COUNCIL MEETING

CONCEPT PLAN

Hillmont

April 6, 2022

Conceptual Site Plan
021133 | January 25, 2022
© 2022 Cline Design Associates, PA. The graphics are illustrative and not to scale.

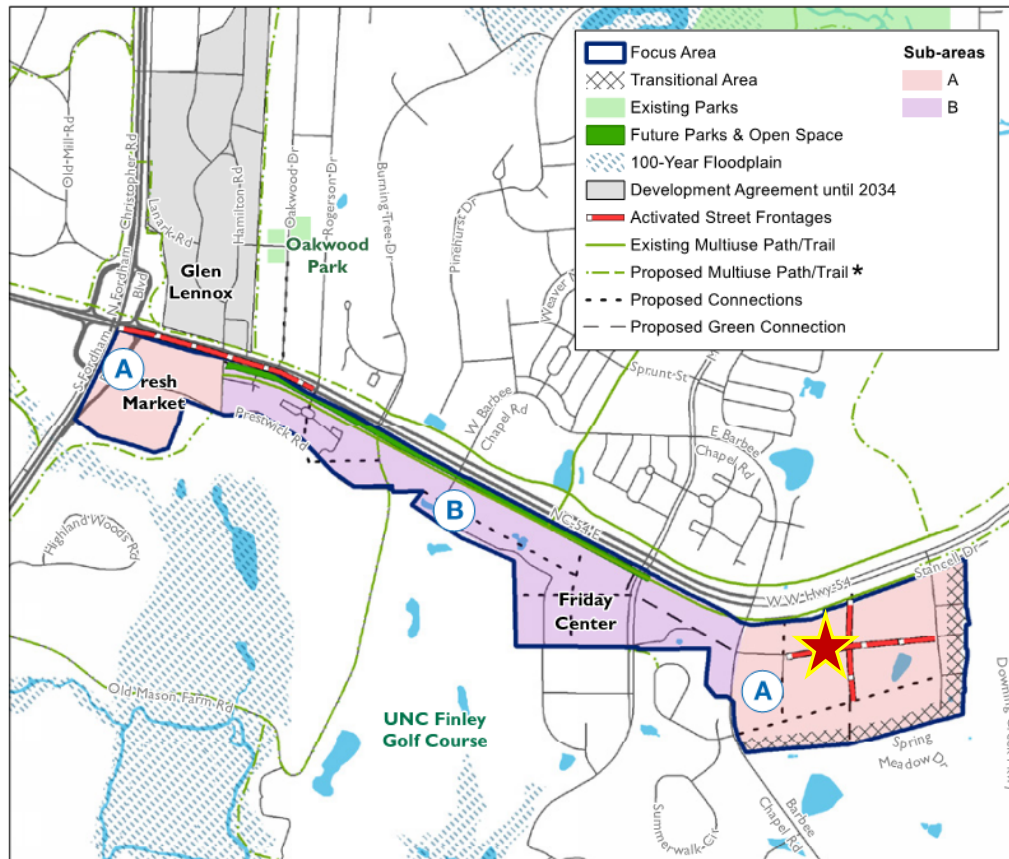
1. Main Street focus
2. Street trees
3. Pool and landscape courtyard
4. Internal sidewalks
5. Trail system
6. Stoops and porches

Provide more bump outs w/ trees & trees where bump outs are currently shown.

consider sidewalk extension

consider informal trail access to natural area

consider swapping pool & courtyard locations. Courtyard could become public (community) amenity along primary frontage and near main building entrance

Consider bump-out or other traffic calming method to help differentiate between "main street" (townhouse fronts) from "back" perimeter street
